ADDENDUM #3

August 27, 2025

**CRAWFORDSVILLE READINESS CENTER MODERNIZATION
INDIANA NATIONAL GUARD
CRAWFORDSVILLE, INDIANA**

IFB NO: MDI-SAB-26-B-013

ABI1
A321

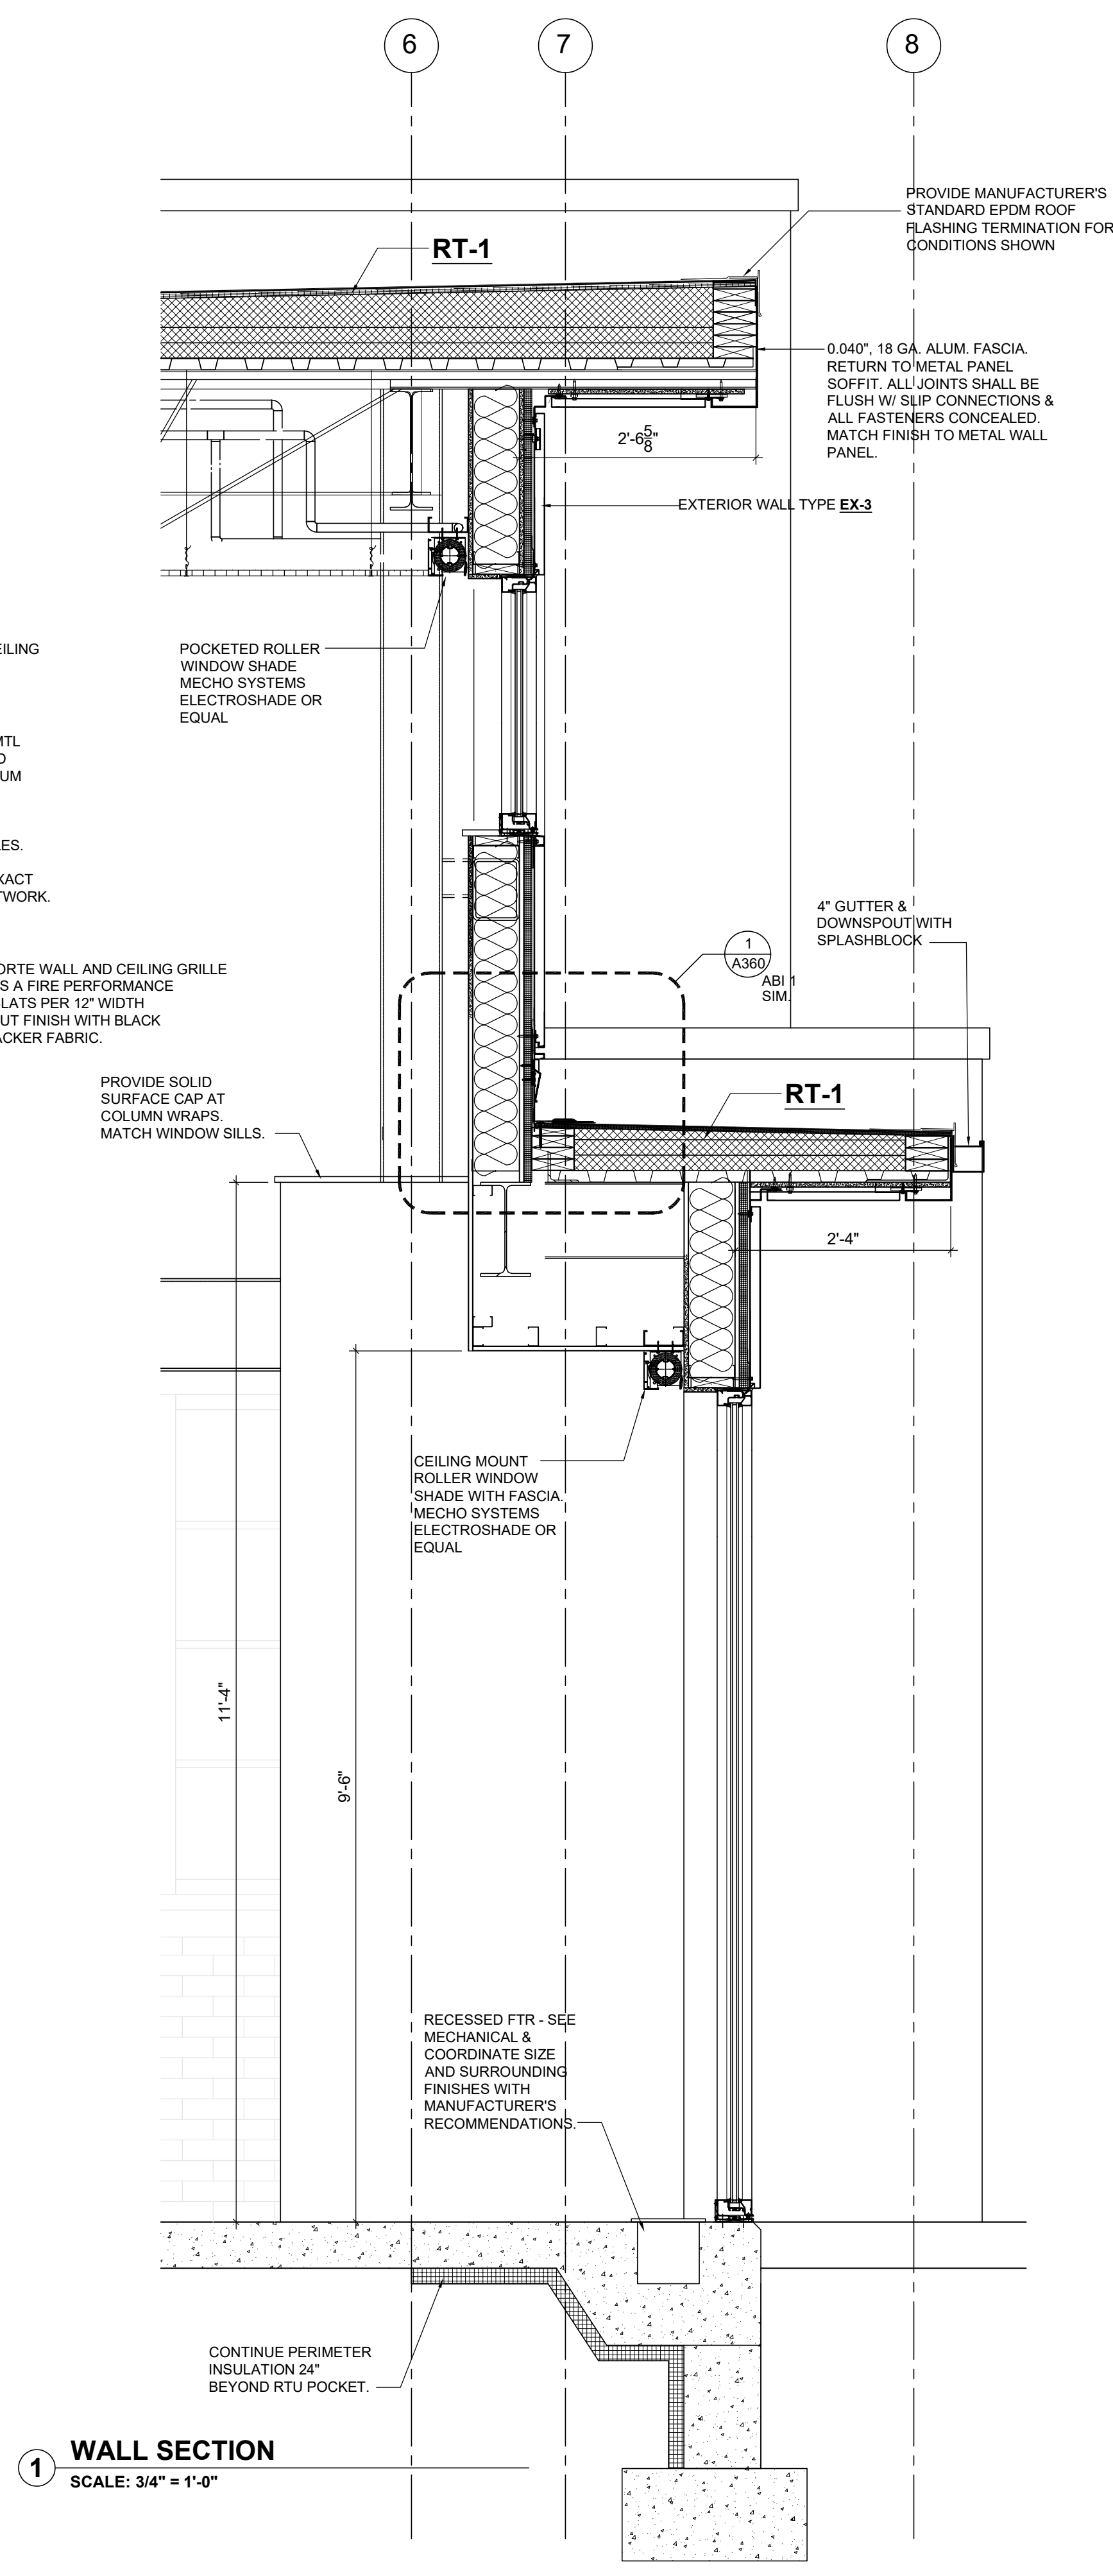
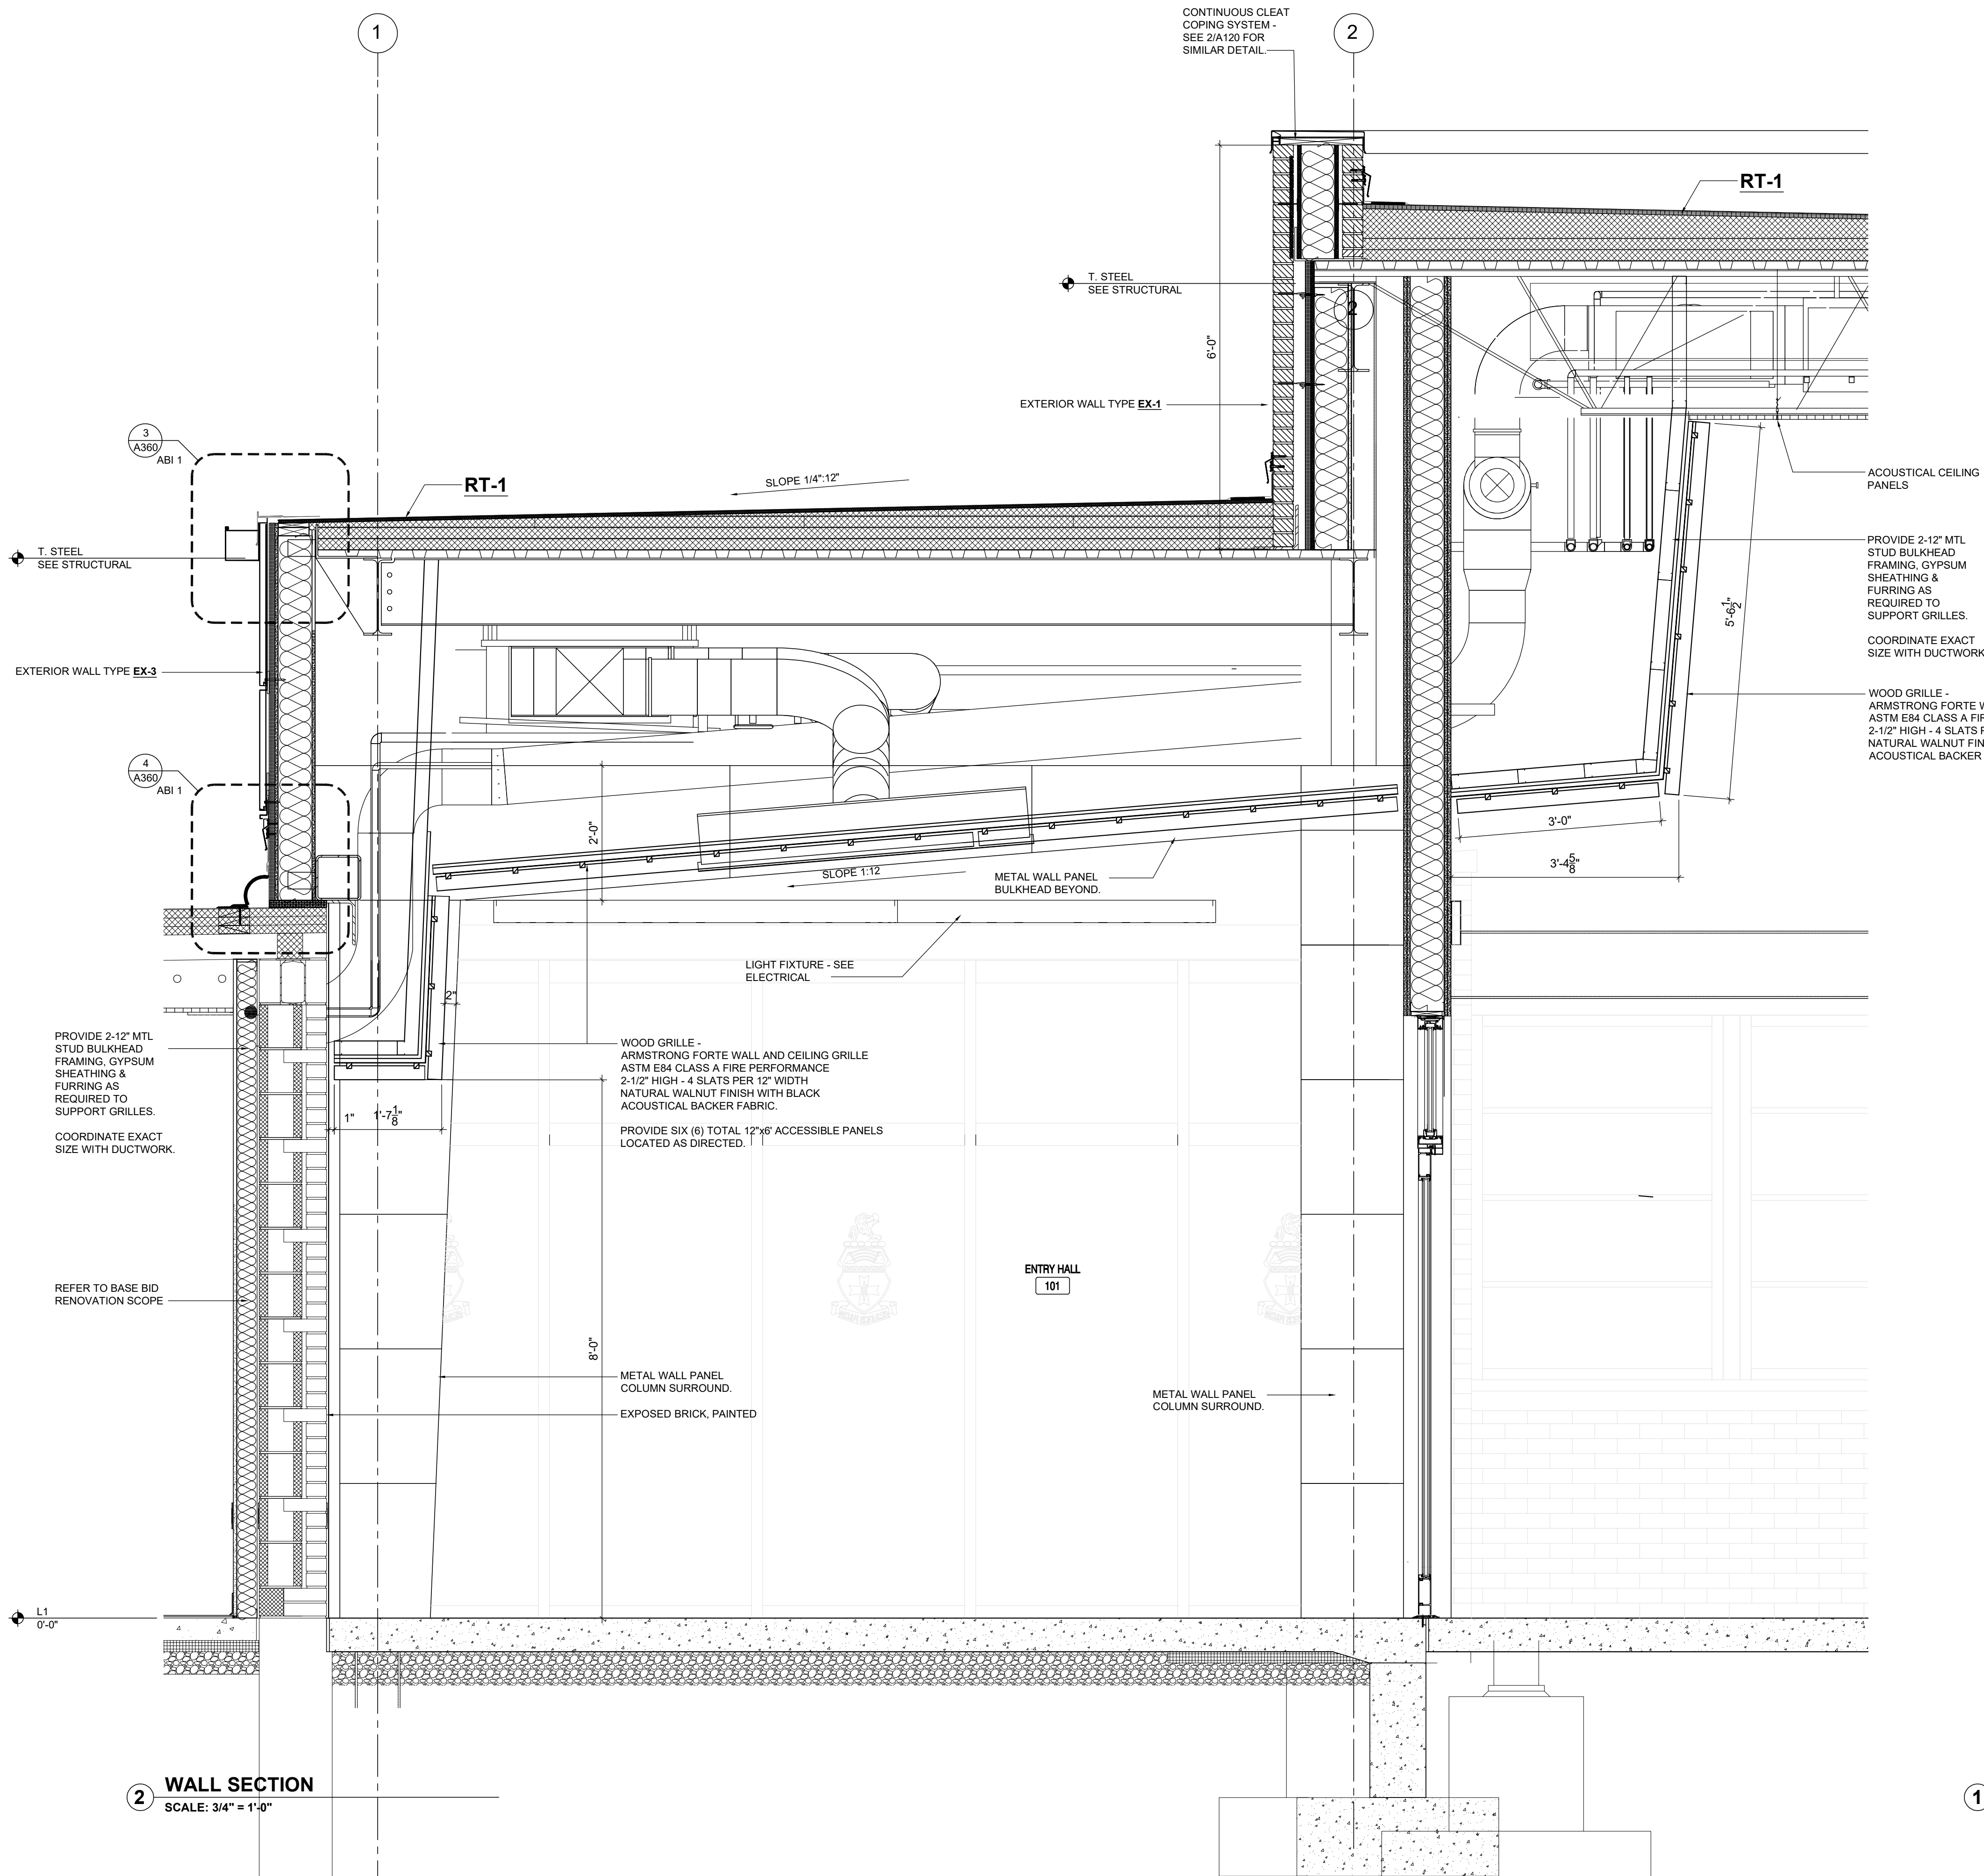
- Response:** Please Refer to Sheet ABI 1 A322, attached to this Addendum for details.
19. **Question:** On ABI 1 A110, it calls for CL2 throughout the entire Entry Hall 101 space, which the legend tells us it is existing and gets repainted. With this being a new addition, it will not be existing- can we get product numbers for these metal panel ceilings?

- Response:** Metal panels are used for the column surrounds and the bulkeads connecting the column surrounds only. Outside of this area, the exposed structure is to be painted. See ABI 1 A321 for details.
